Allied Paper, Inc./ Portage Creek/  
Kalamazoo River Superfund Site

## Former Plainwell Impoundment 2010 Bank Conditions Monitoring Report

Subject:  
Former Plainwell Impoundment 2010 Bank Conditions Monitoring Report  
Allied Paper, Inc./Portage Creek/Kalamazoo River Superfund Site

A draft copy of the Monitoring Report dated January 26, 2011 was submitted to USEPA in February 2011. In a letter dated April 8, 2011, USEPA submitted comments on the draft Monitoring Report. Those comments have been addressed in the enclosed final Monitoring Report. A summary of the responses to USEPA comments is included below.

**MONITORING TRANSECT  
CROSS SECTIONS - T-1 AND T-2**

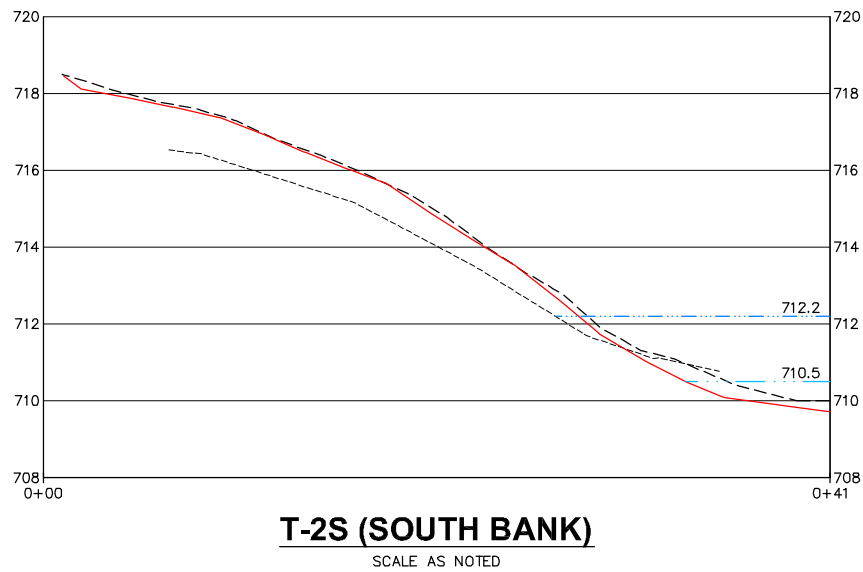
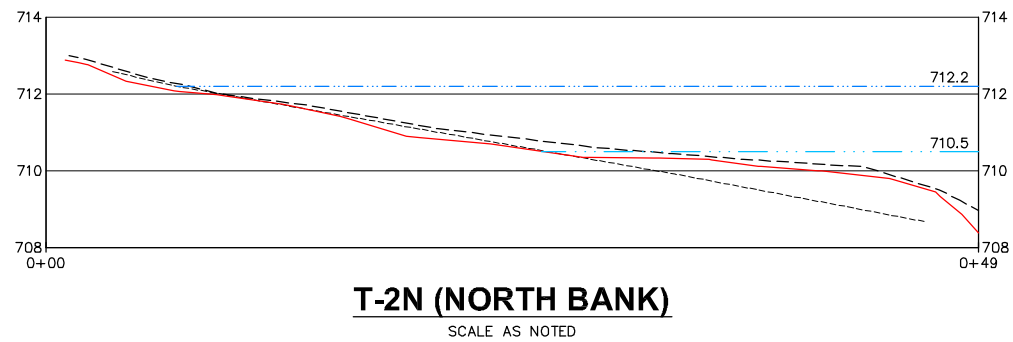
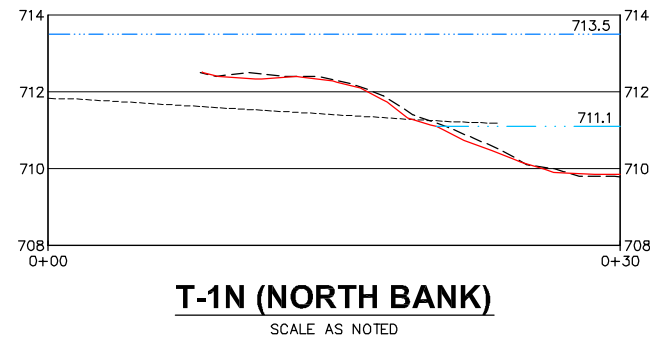
**USEPA Comment 2: Section 4.2, Comparison of Surveyed Banks:** Some of the text descriptions in this section appear to be inconsistent with the bank profiles. Some of the bank profiles show erosion between the 2009 and 2010 monitoring events and needs to be more clearly indicated in the text description (e.g. T-2S, T-

**ARCADIS Response:** The report will be revised to make the bank descriptions consistent with the bank profiles and explain which transects did not evaluate the bank toe. Individual bank descriptions will be revised as follows:

- T-2S – This transect is located on the south bank in Removal Area 3B. It appears to be similar to its design with a stable slope to a point between the prism-out 2-year and median water elevations. ~~and some possible sediment buildup on the bank and at the toe of the bank.~~ Below this point, some toe erosion can be noted. ~~There is no apparent change in the geometry of the restored bank at this location from 2009 to 2010.~~ This bank is currently characterized as stable.

FIGURE  
4

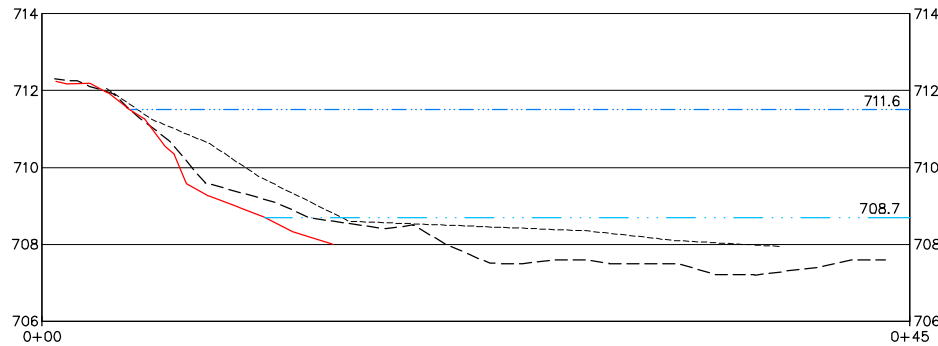
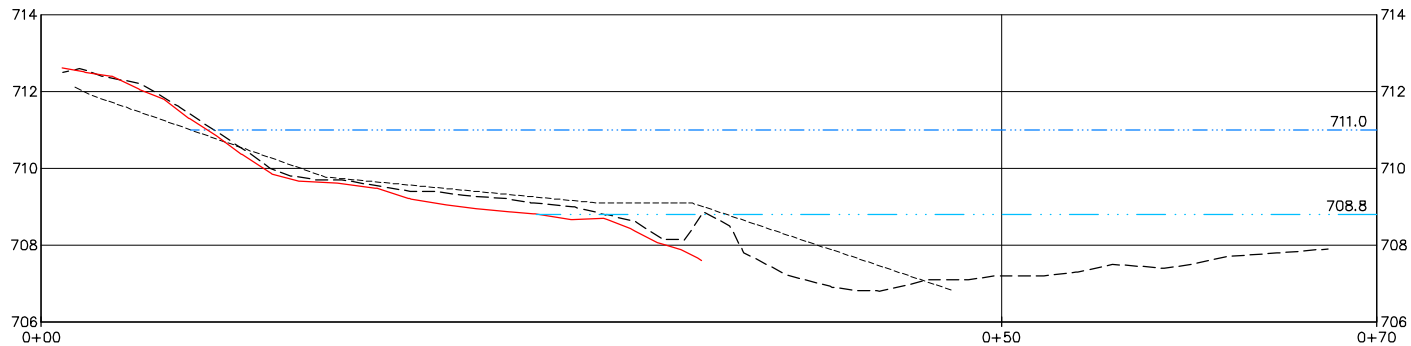
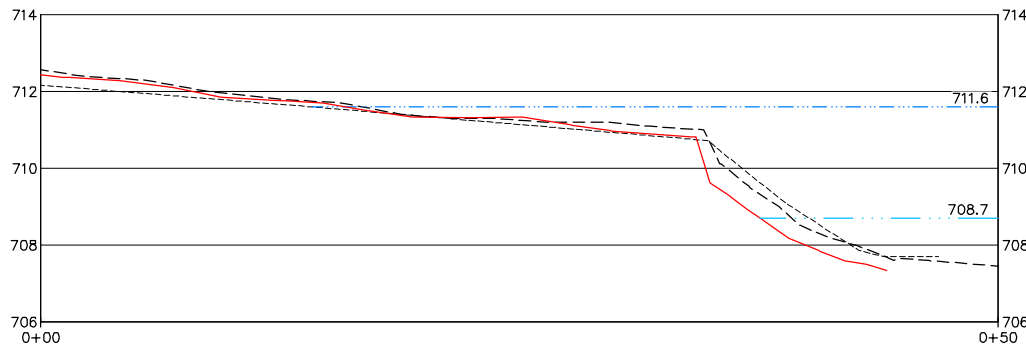
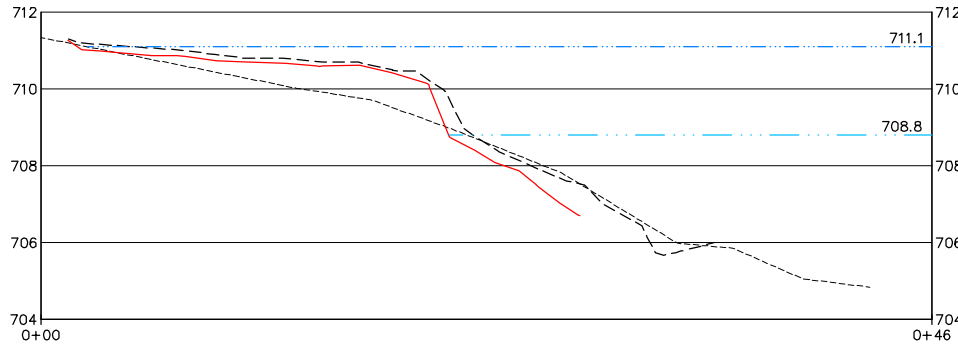
4N, T-4S, T-6S). The issue of the truncated profiles plays into limiting the utility of the description.

- T-3N – This transect is located on the north bank in Removal Area 4A. A small amount of erosion may be indicated by the differences between design and survey, but a stable bank slope appears to have established. The bank angle appears to have increased from 2009 to 2010 as some material has eroded. The 2010 transect survey did not extend to the toe of bank to enable an evaluation of the status of the bank toe. This transect is slightly downstream of the bank area that exhibited an increase in bank erosion potential from 2009 to 2010 due to erosion creating a more vertical bank face. The erosion observed does not appear to be affecting the stability of the bank at this location. This bank is currently characterized as stable.

- T-4N – This transect is located on the north bank in Removal Area 5A. The bank at this location currently appears very similar to the geometry observed in 2009. The 2010 survey did not extend to the toe of slope to enable an assessment of its stability. Overall, this bank is currently characterized as stable.

- T-4S – This transect is located on the south bank in Removal Area 4B. The accumulation of sediment at the top-of-bank that was observed in 2009 exhibits some slight erosion and bank steepening. The lower portion of the bank exhibits a stable slope but also shows signs of some lateral erosion. The 2010 survey did not extend to the bank toe to enable an assessment of its stability. Overall, this portion of the bank is remaining stable.
